APPROVED REVISION(S)  
TO BUILDING PERMIT NO. 25-1396  
DATE 9.30.25  
PER   
CITY OF CREVE COEUR

date: 4/23/2025  
PERMIT: 7/11/2025  
CITY COMMENTS: 8/15/2025  
REVISIONS: 9/29/2025

9820 Warington Square  
Creve Coeur, MO 63141

NEW RESIDENCE AT:

## FOUNDATION PLAN

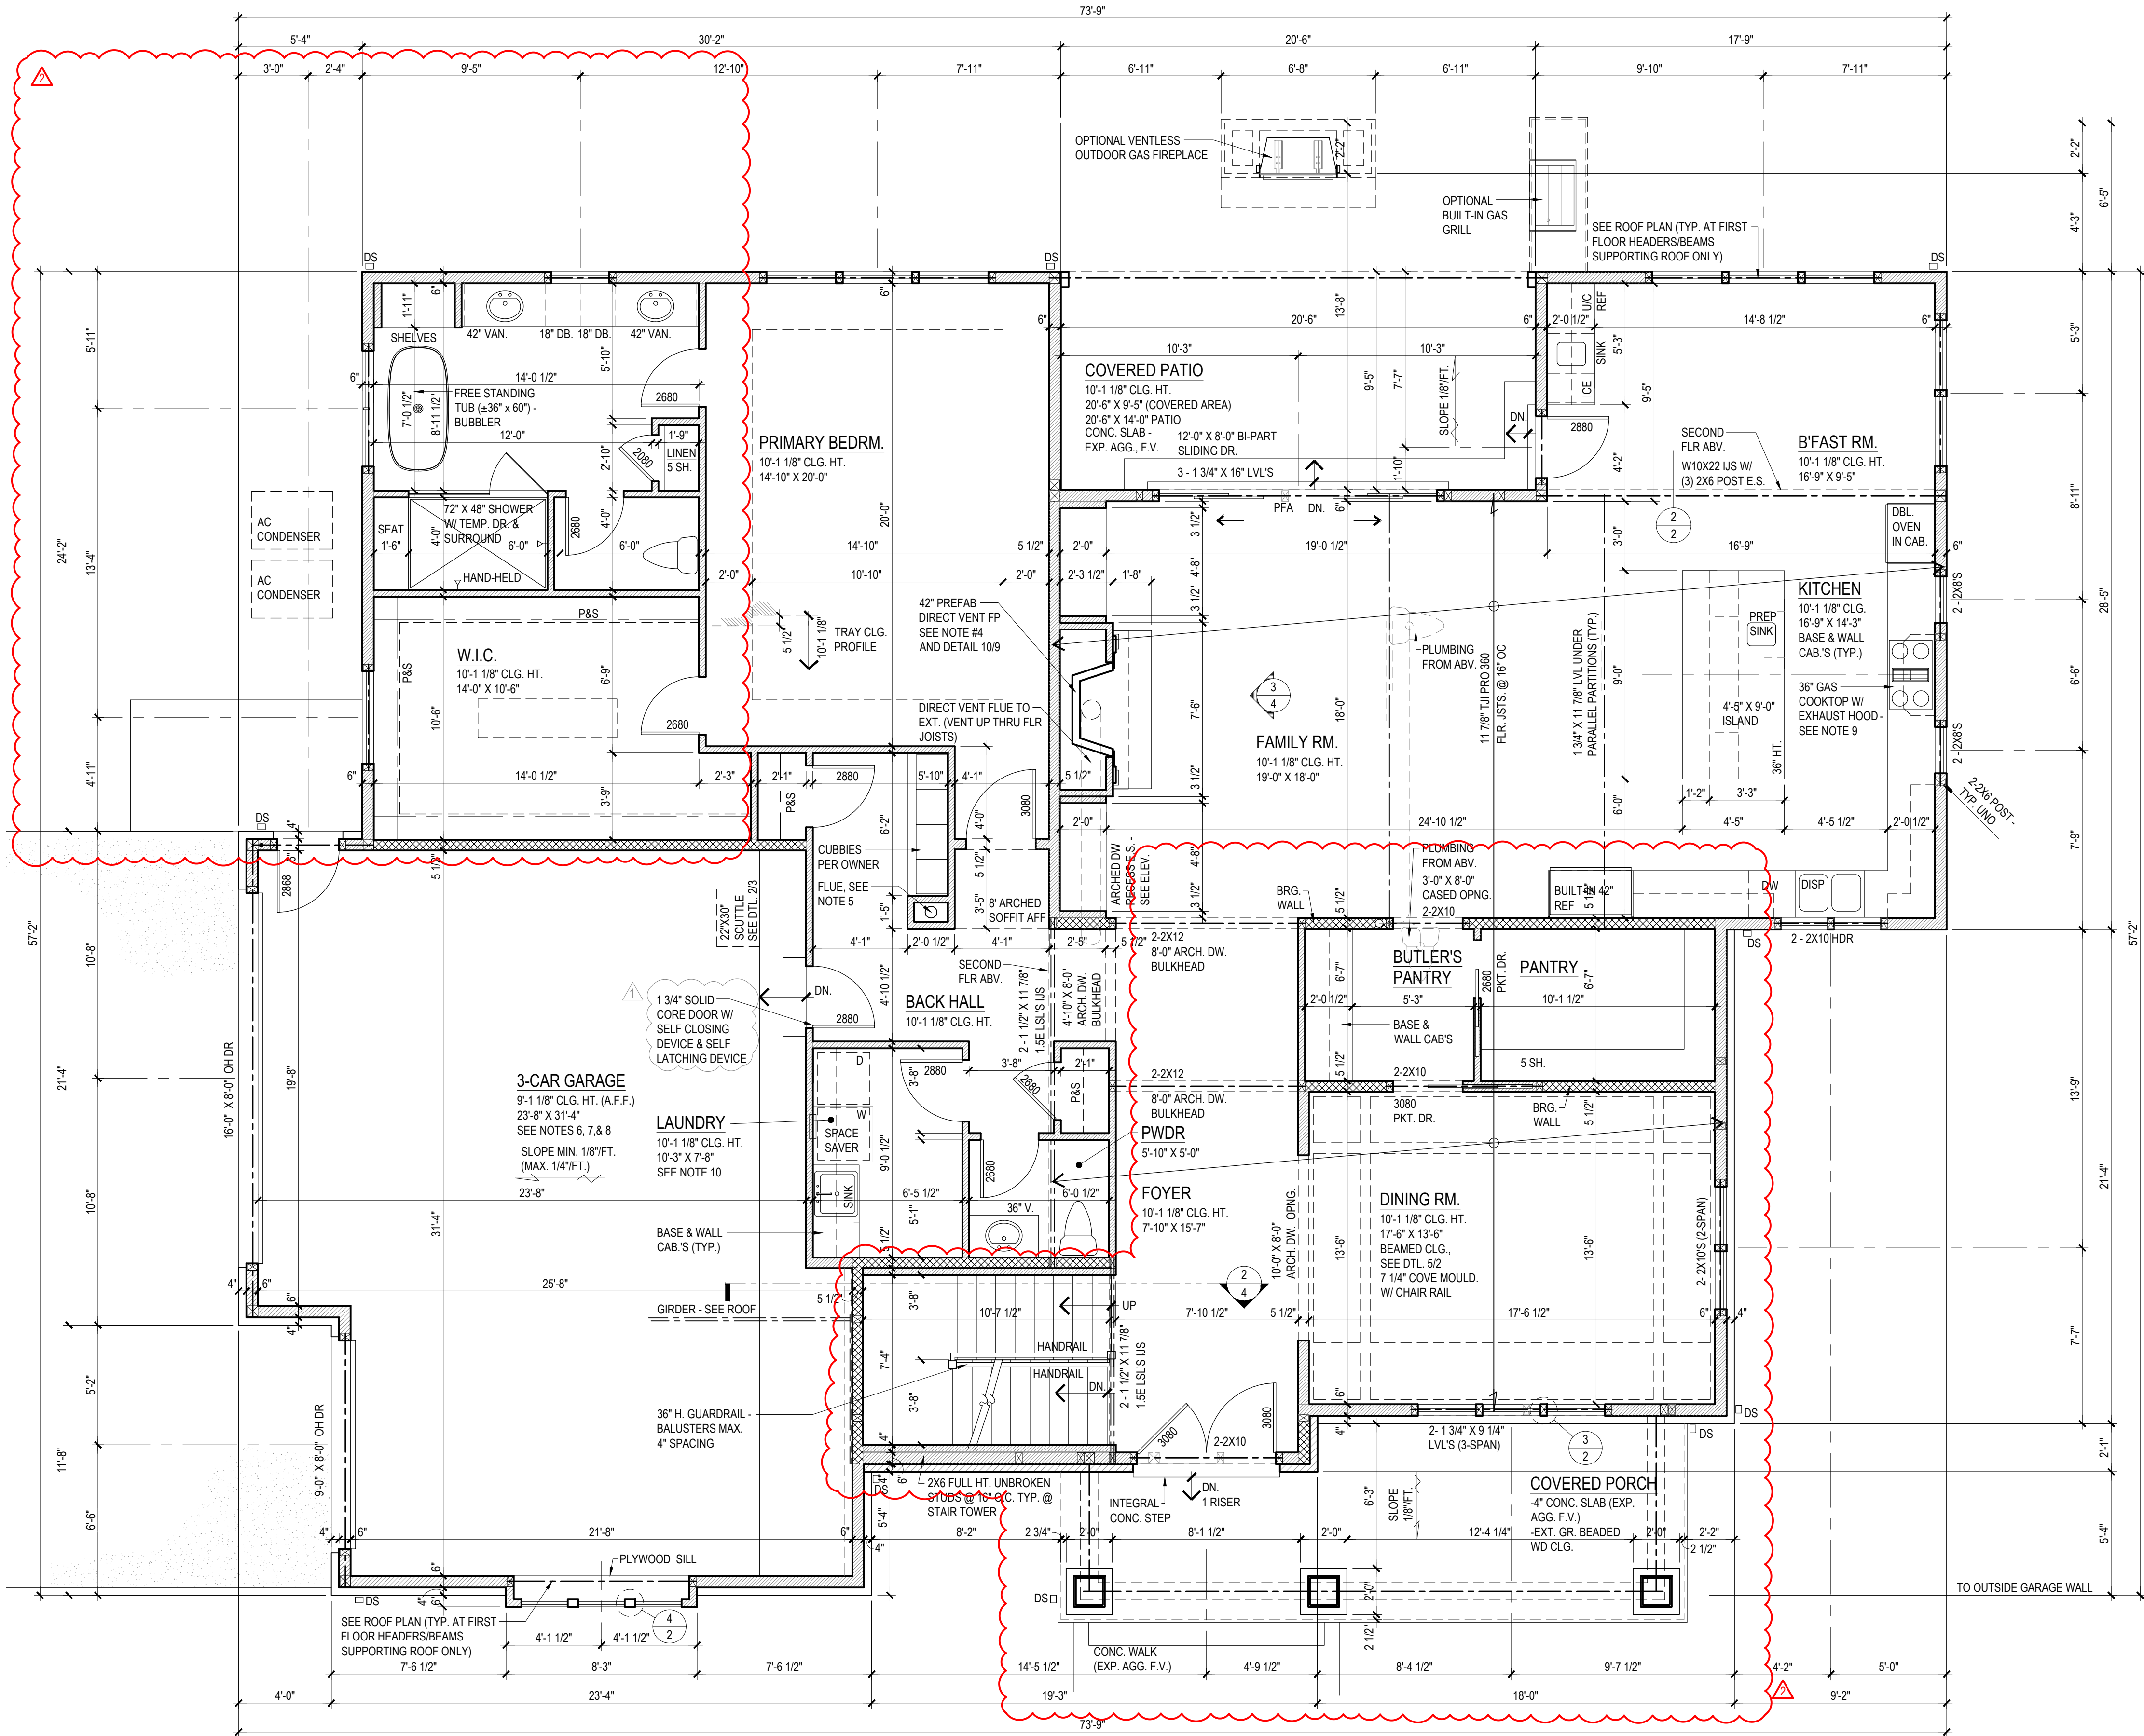
OVERALL FOUNDATION PLAN  
CHANGE - WALL THICKNESS  
HAS CHANGED FROM 12"  
THICK TO 10" THICK
